**The Woodlands Off-Site Sanitary Lift Station, Force Main & Gravity Sewer Line A (RFCSP)**

**Solicitation Number: CO-00682**

**ADDENDUM 3**

**November 15, 2023**

SHEET NO.  
**E-7**

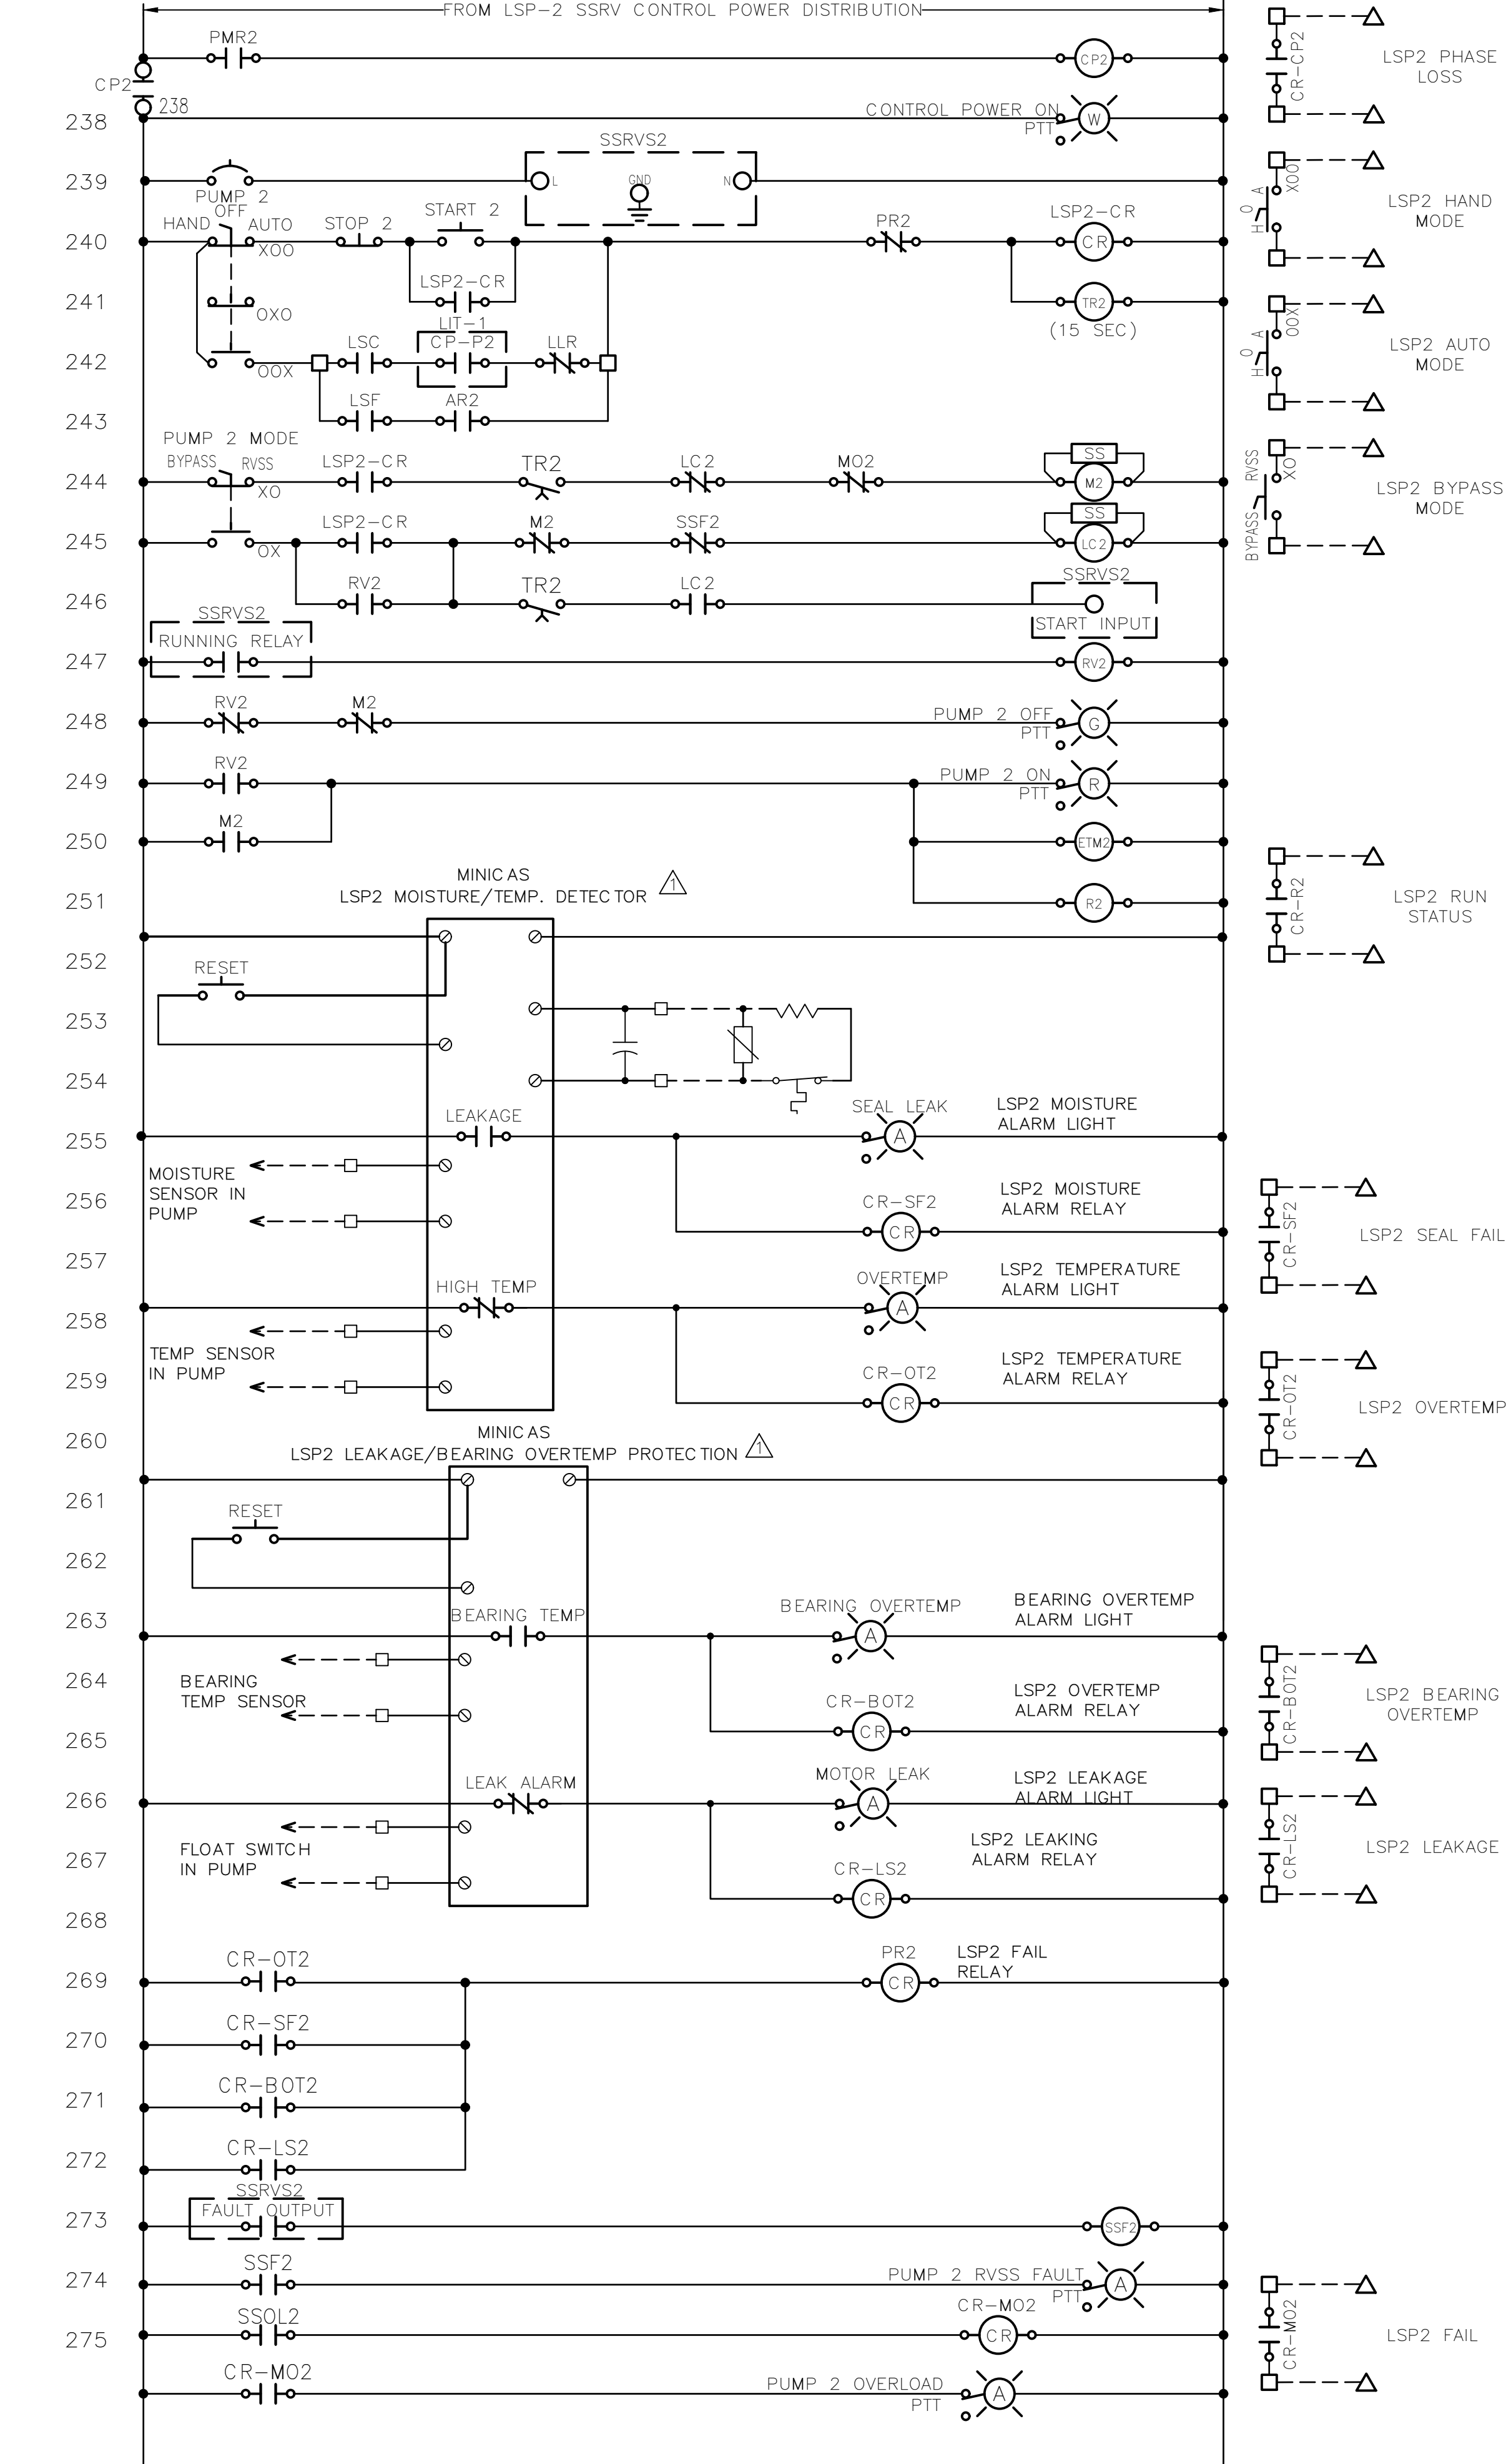
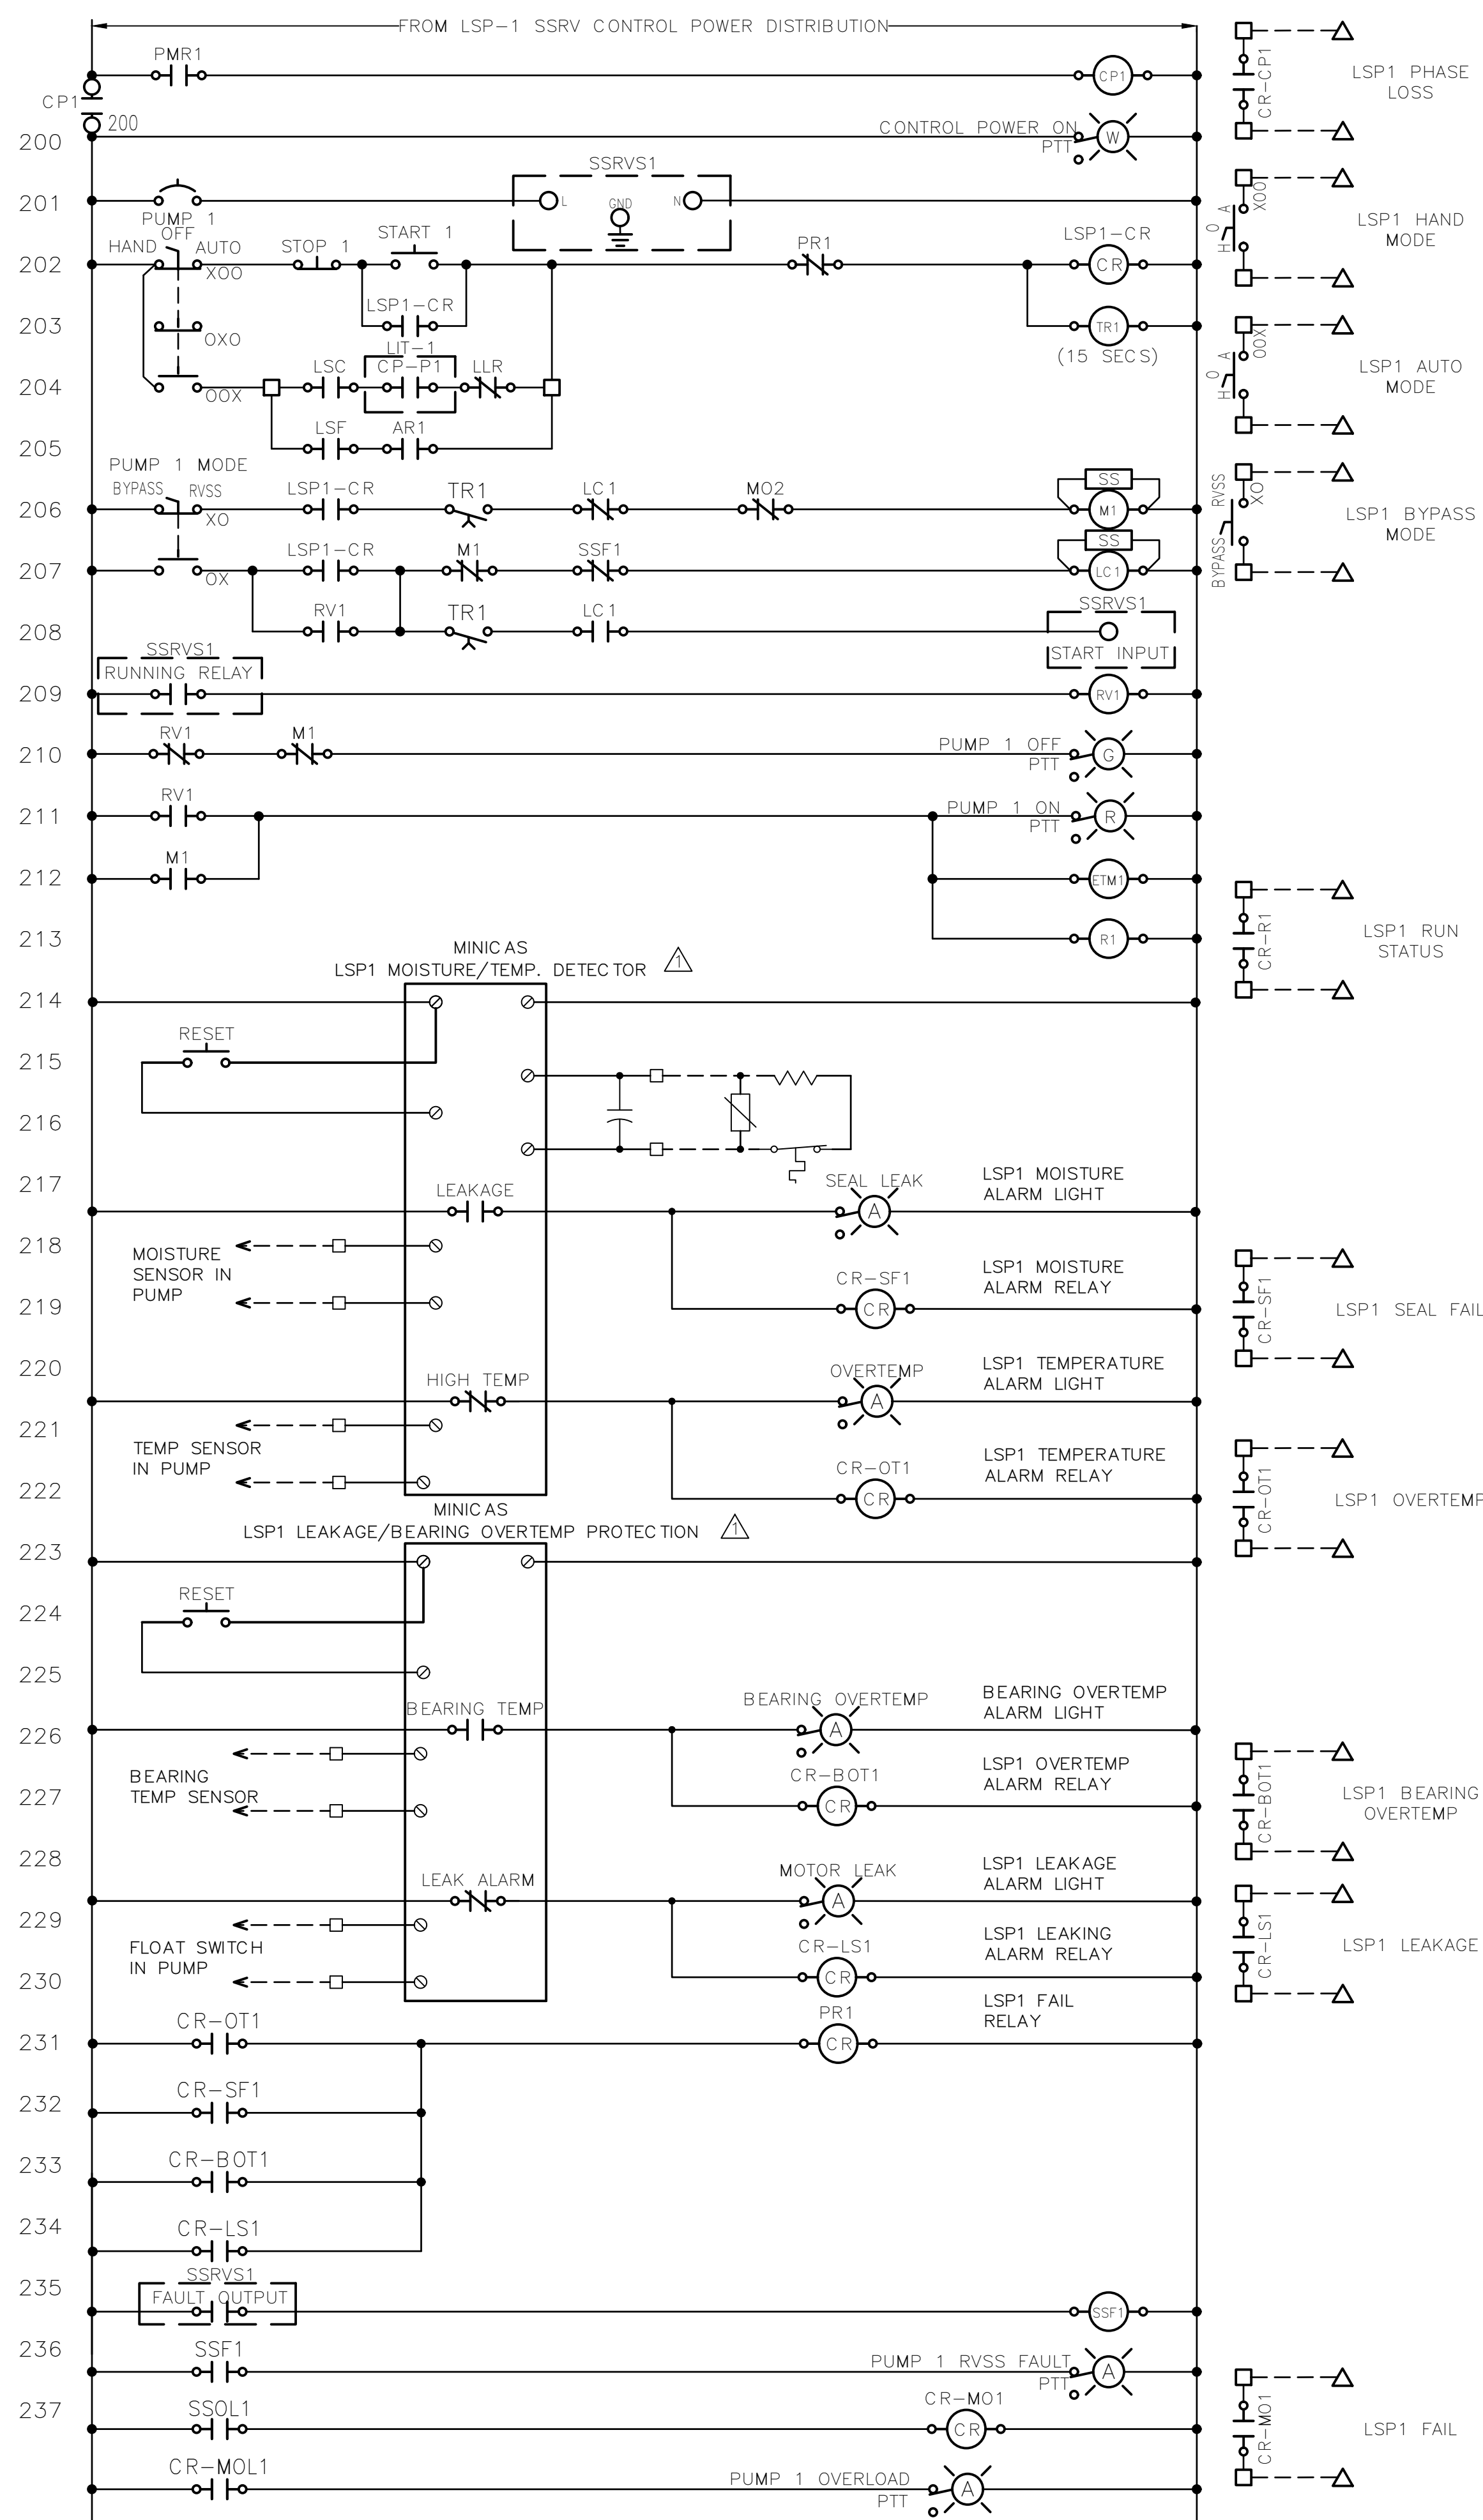
18. **Question:** The one-line diagram on E-3 shows circuits P1-A, P2-A, P3-A, & P4-A routed to the lift pump soft starters. However, sheet E-7 shows these circuits to be routed to the LCP. Please clarify which is correct.

**Answer:** *P1-A, P2-A, P3-A should all be routed to the respective SSRV. See Changes to the Plans #1. Sheets E-7, E-10, and E-11 have been revised accordingly.*
